CITY OF TONTITOWN PLANNING OFFICE

Meeting: **February 26, 2019**
Project: **La Bodega Wholesale Foods**
Planner: Courtney McNair

- i. **CONDITIONAL USE PERMIT REQUEST**
- ii. **PRELIMINARY LARGE SCALE DEVELOPMENT PLAN APPROVAL REQUEST &**
- iii. **WAIVER REQUEST**

West of 585 Jean Mary Drive
Parcel # 830-37833-000

A2.1
COLOR ELEVATIONS

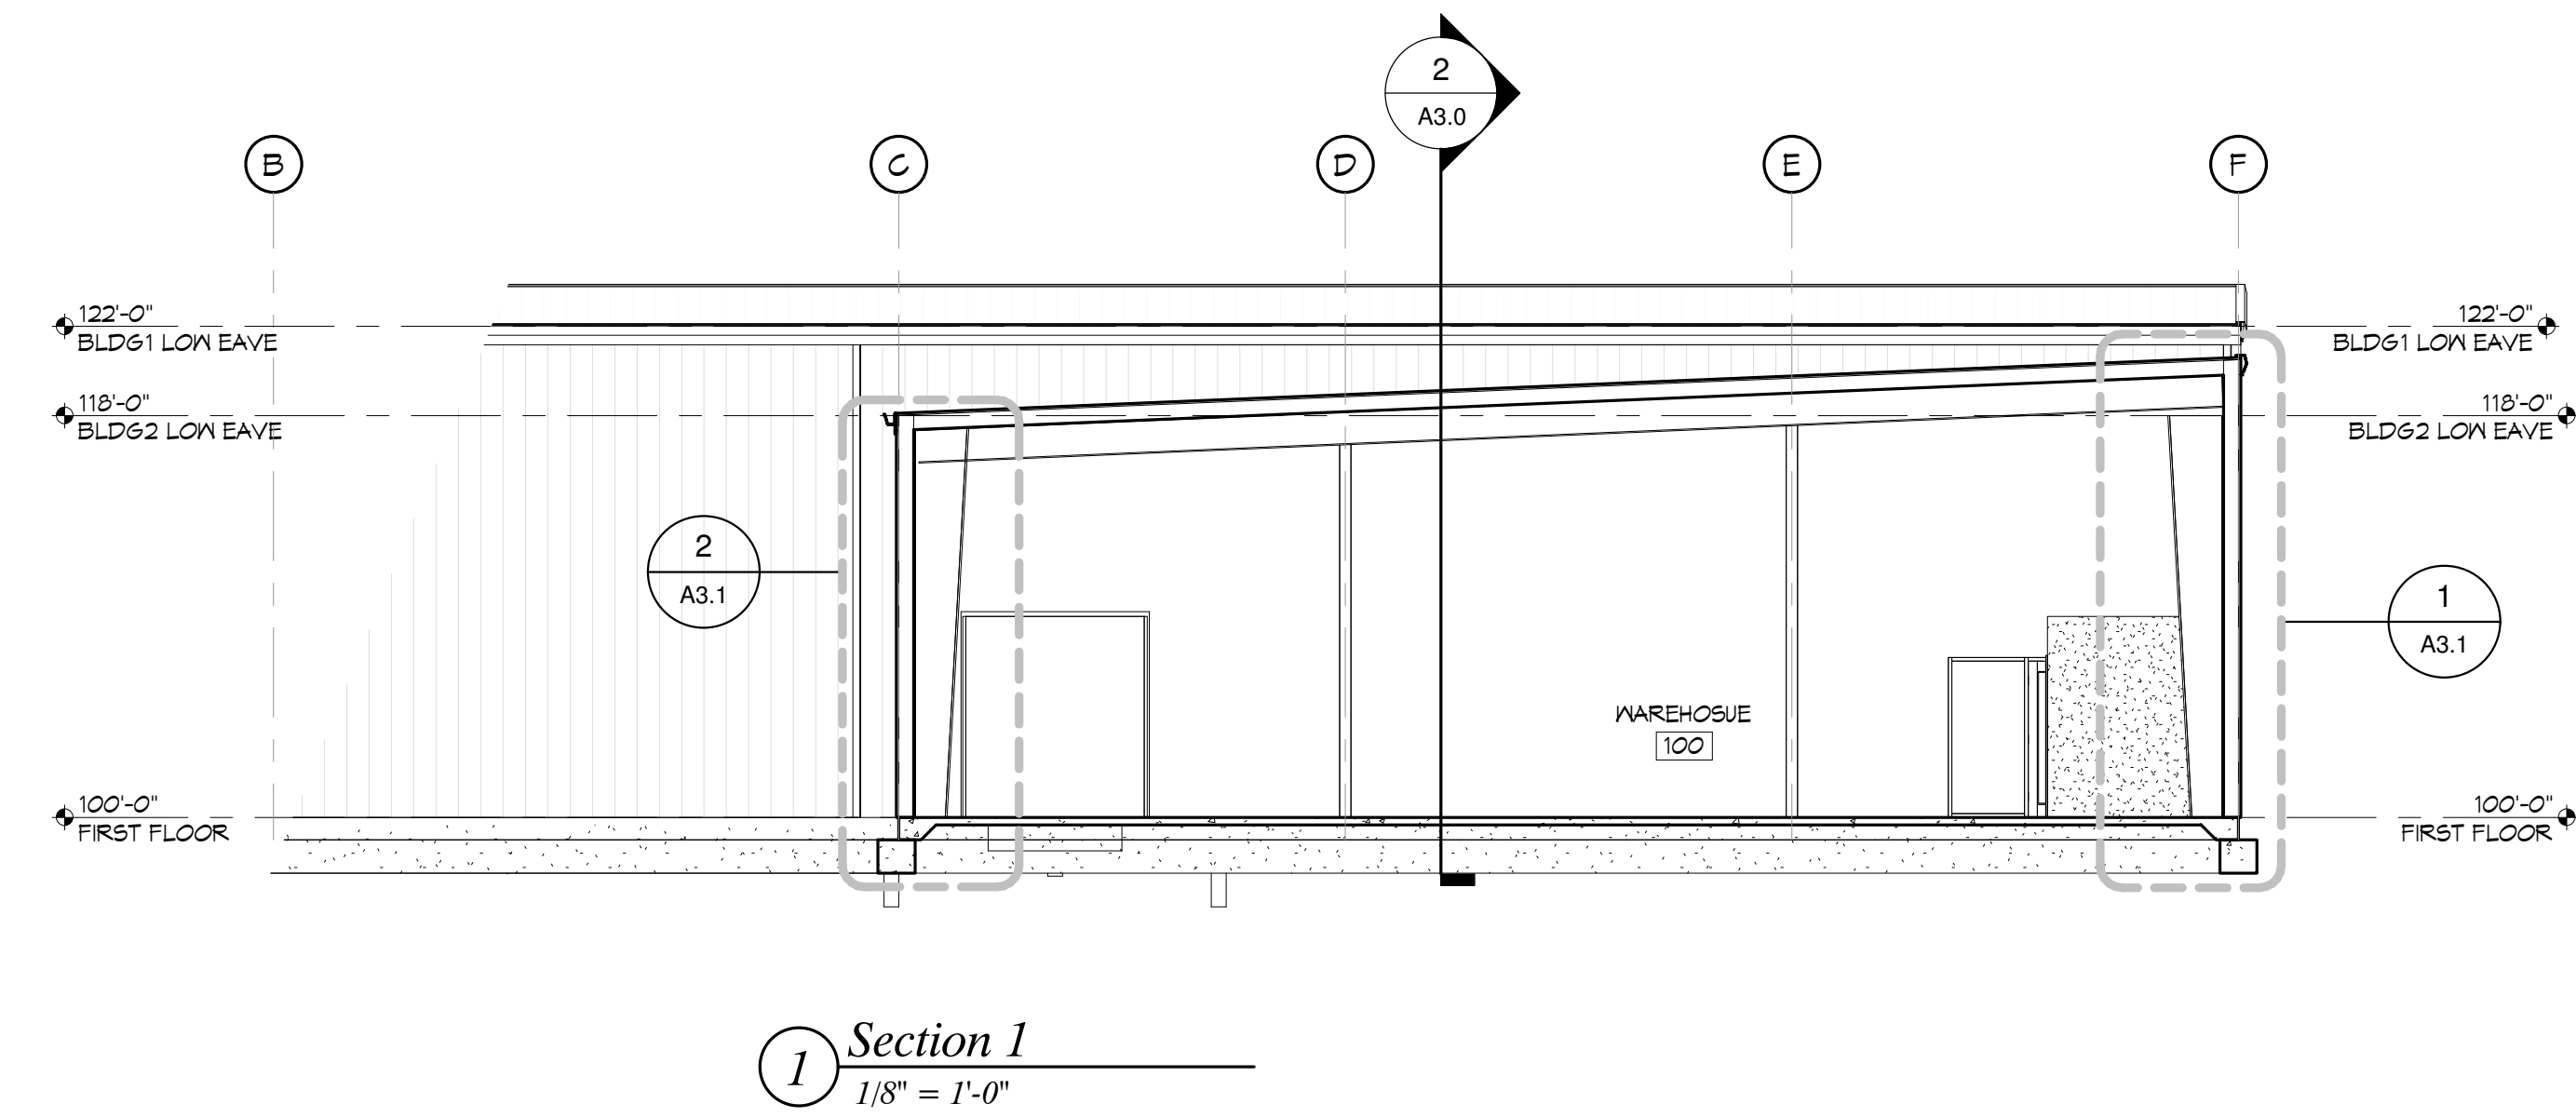
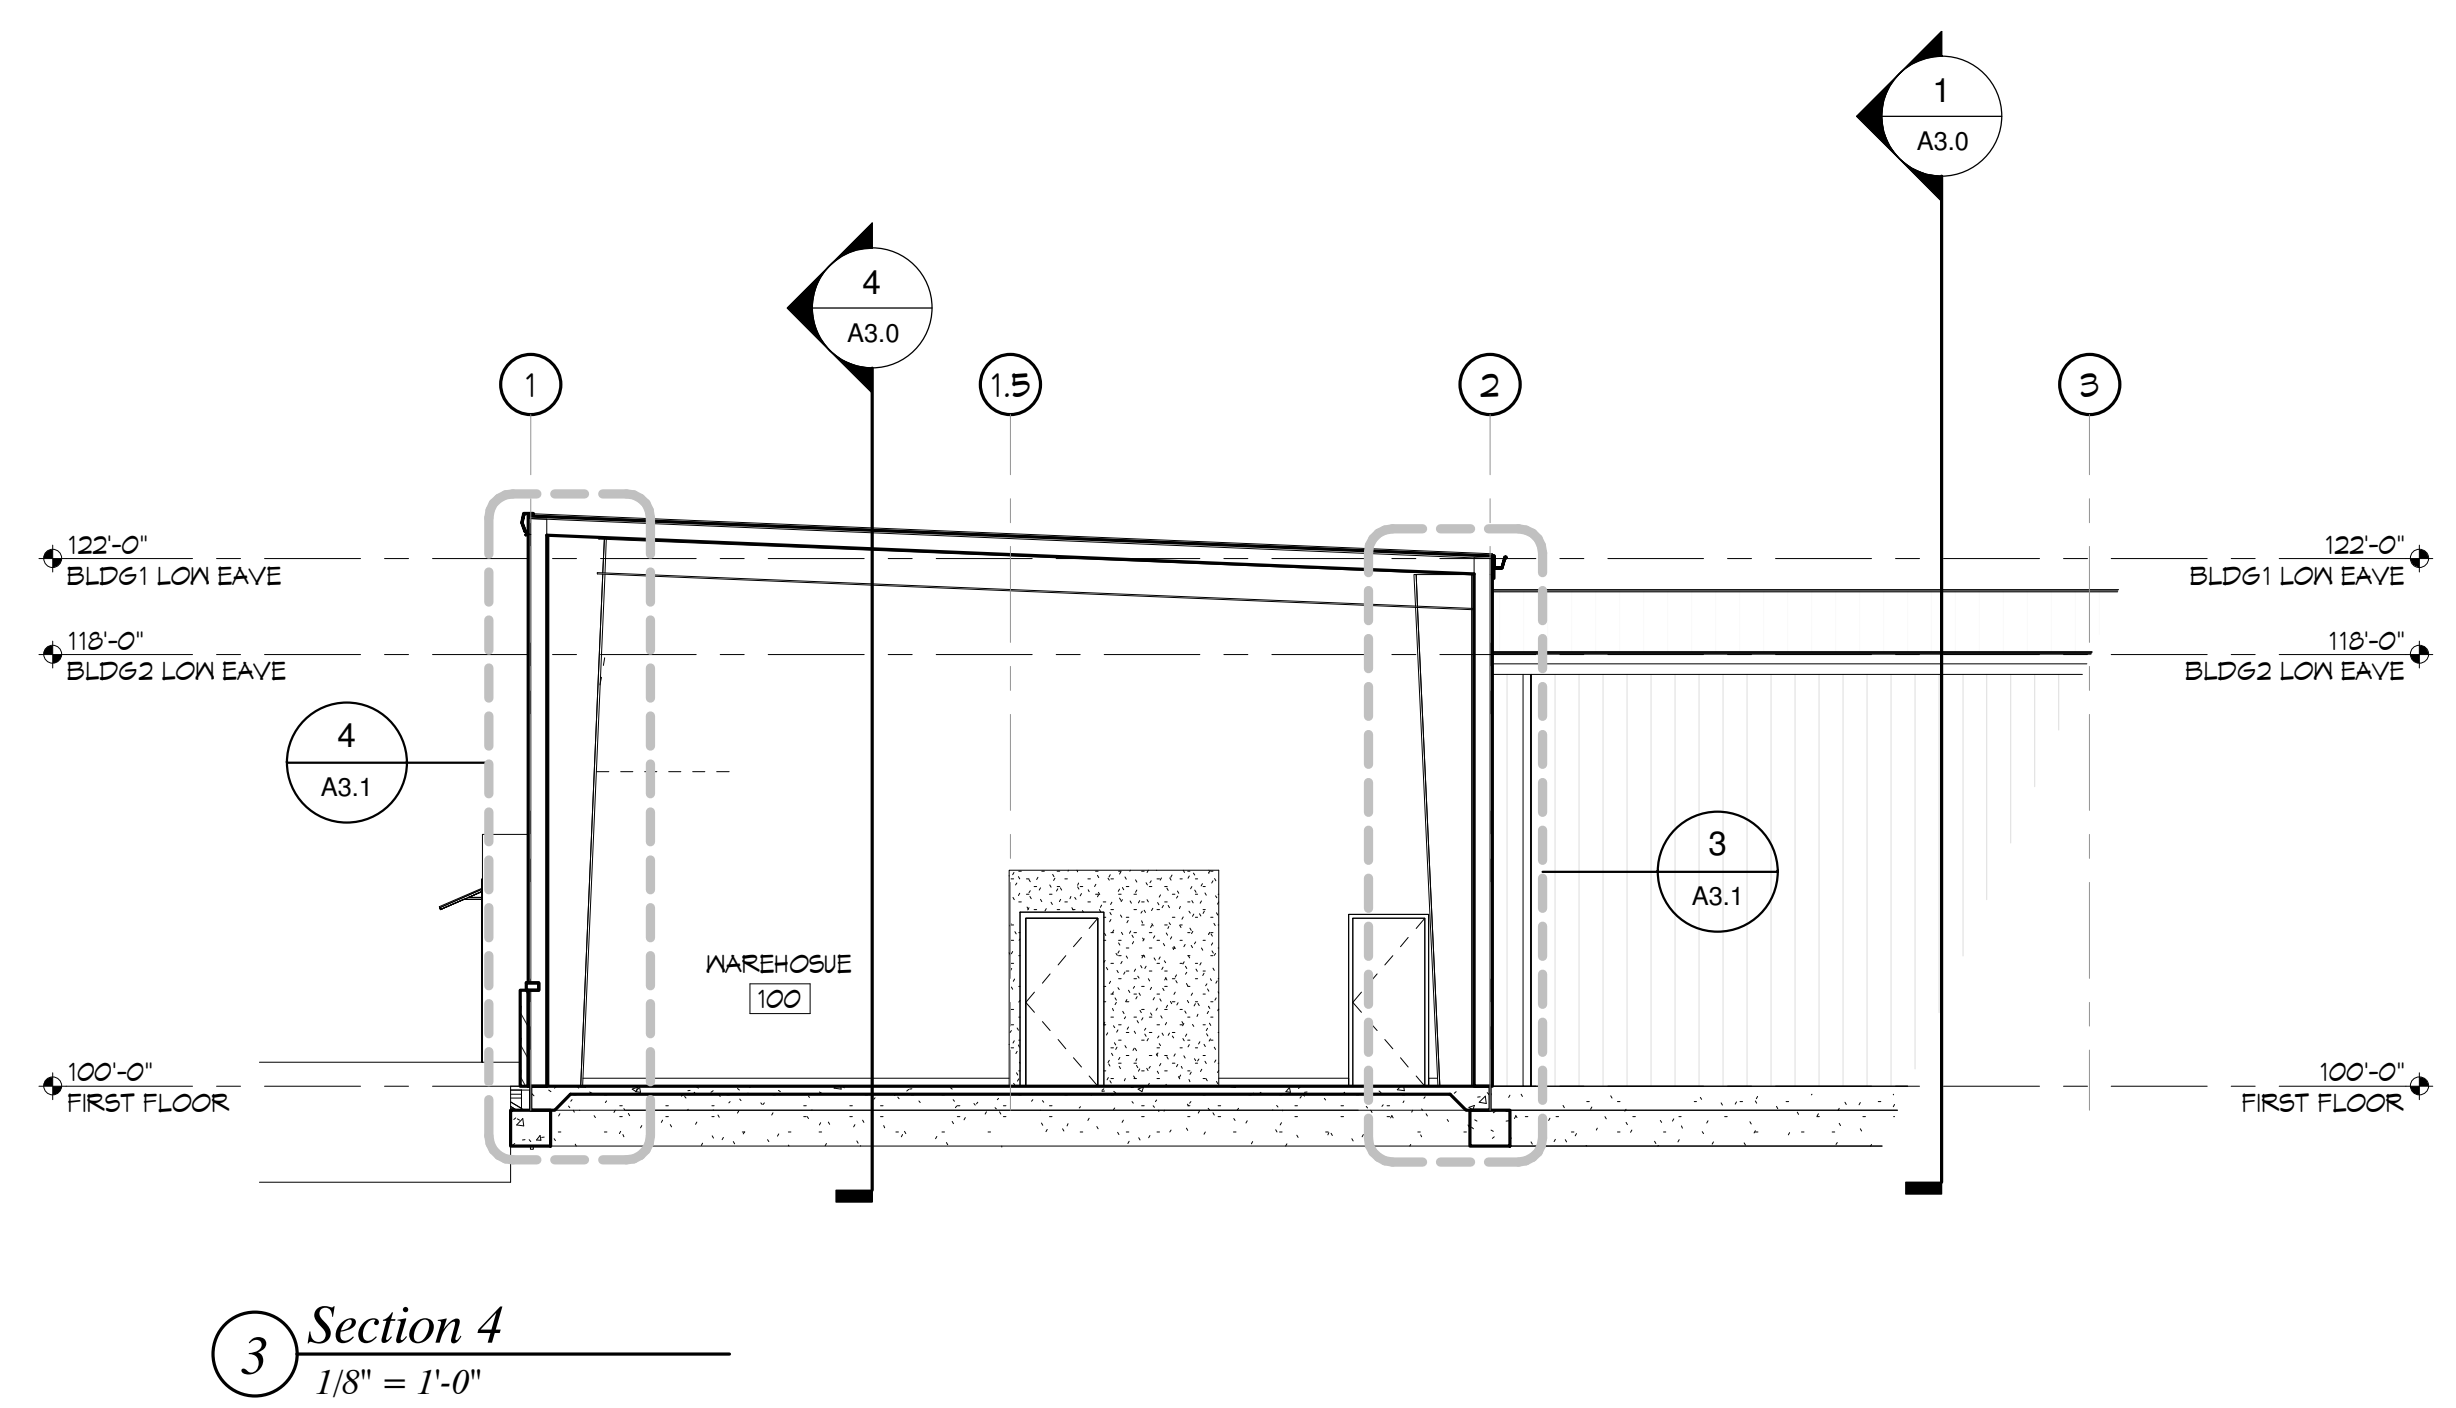
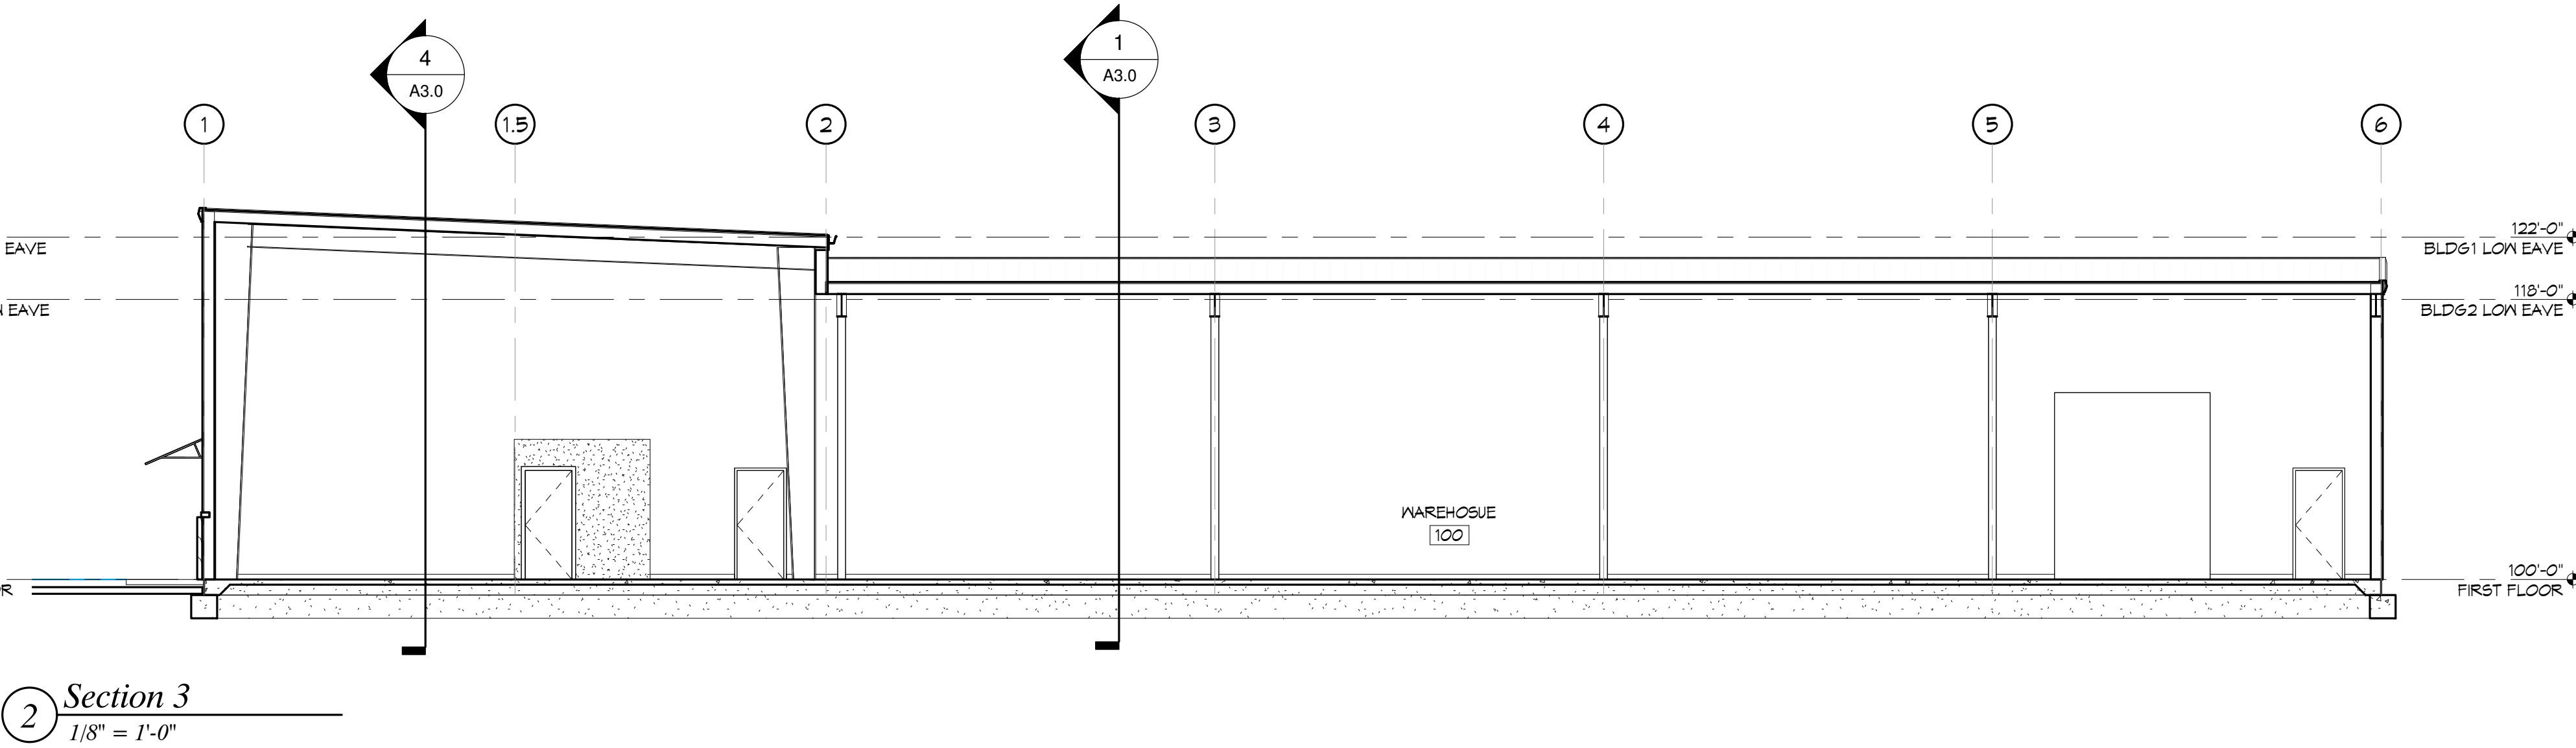
Architectural plans were submitted. The plans submitted do not meet the 75% masonry requirement, they do not meet the roof line articulation requirement, only one architectural feature is provided at the entrance (two are required), and they are only showing one architectural feature for the front façade (three are required).

Architectural plans were submitted. The plans submitted do not meet the 75% masonry requirement, they do not meet the roof line articulation requirement, only one architectural feature is provided at the entrance (two are required), and they are only showing one architectural feature for the front façade (three are required).

The applicant is requesting a waiver from the required architectural elements. The surrounding buildings are primarily blue metal panel. The proposed building will have a neutral color tone and have a split face block wainscot on the street façade. The applicant states that the “added material and natural color combination will enhance the area while still being in keeping with the surrounding architecture.”

However, staff does feel the building should incorporate the remainder of the required architectural features, and will recommend that the Board include these if the waiver is granted. This serves to enhance the area, and provide precedent for future businesses that are similar, while remaining reasonable for this type of development.

STAFF RECOMMENDATION: Staff recommends approval of the waiver allowing less than 75% masonry façade with conditions to require the additional architectural elements.
